### Design Review Subcommittee (DRSC) Meeting Date: December 15, 2021

SUBJECT: Minor Architectural Permit 21-228, 309 Commercial Façade Improvements, a request to alter the exterior of an industrial building for property located at 309 Calle De Los Molinos in the I2 (Light Industrial) Area of the West Pico Corridor Specific Plan.

#### Exhibit 3: View of Proposed South Elevation of Building

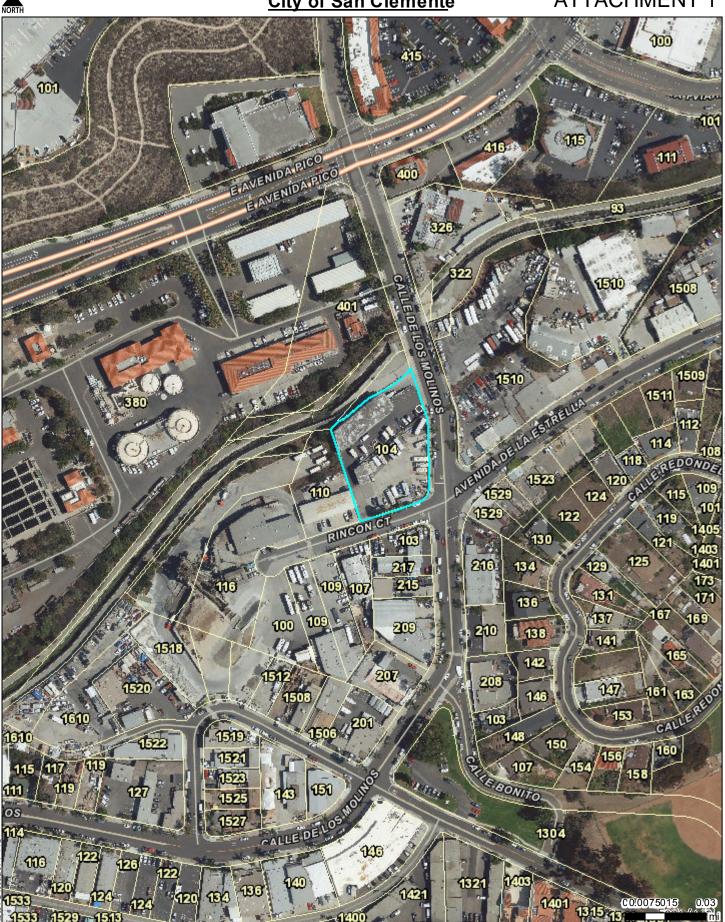
• Recommendation: Use a darker but warm shade of wall color such as tan that complements the roof material. To add texture, consider applying a high grit (rough) plaster finish.

• Recommendation: The materials board shows the corrugated metal roof is unfinished in areas. Staff suggests a dark bronze or brown color for the roof that complements other building materials.

- 1. Apply the water tank rough-sewn wood material to other trim elements of the building such as the trellis patio covers, outdoor decking, roof eaves, and windowsills.
- 2. Window grates and roll-up access doors should have a dark metal finish to match the roof and complement the fencing.

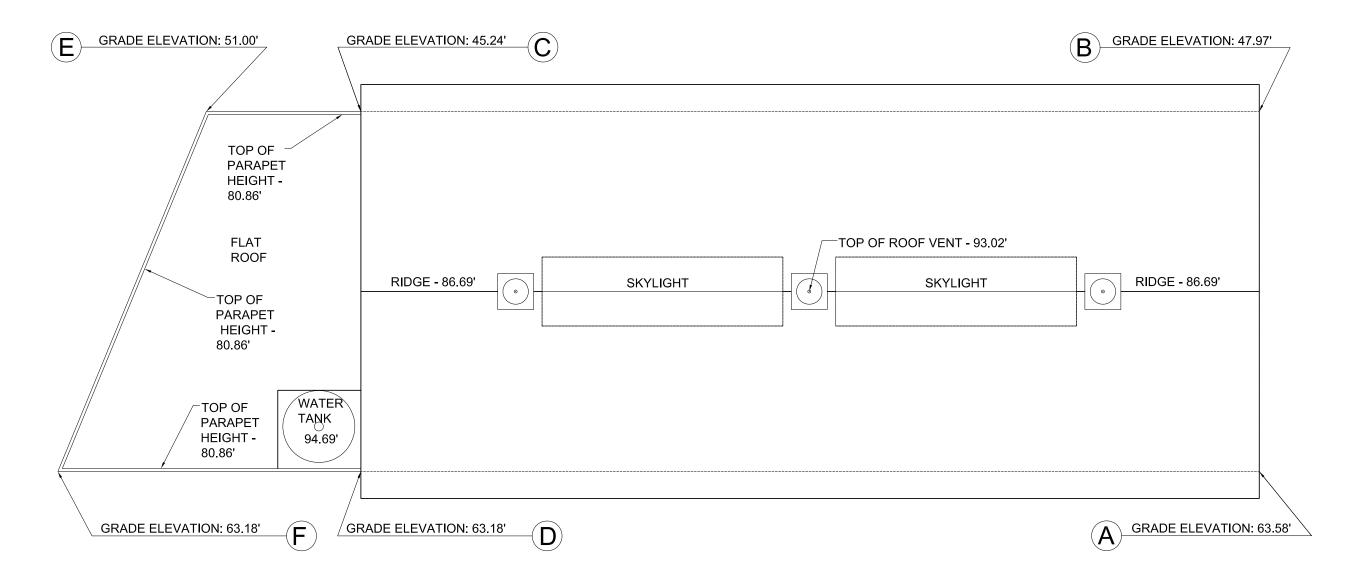
It should be noted that the height of the proposed roof meets the height requirements of the Specific Plan. The applicant has provided a height analysis to demonstrate the average height is below the maximum height requirement (Attachment 2). In addition, the applicant is proposing decorative galvanized roof vents at the peak of the roof. As

proposed, the vents do not meet the height requirement of the Specific Plan. According to the SCMC Table 17.24.080B, a Conditional Use Permit is required to allow cupolas to exceed the height limit in the industrial zone to a maximum of 10 feet. Staff is seeking feedback as to whether the vents are considered as cupolas.
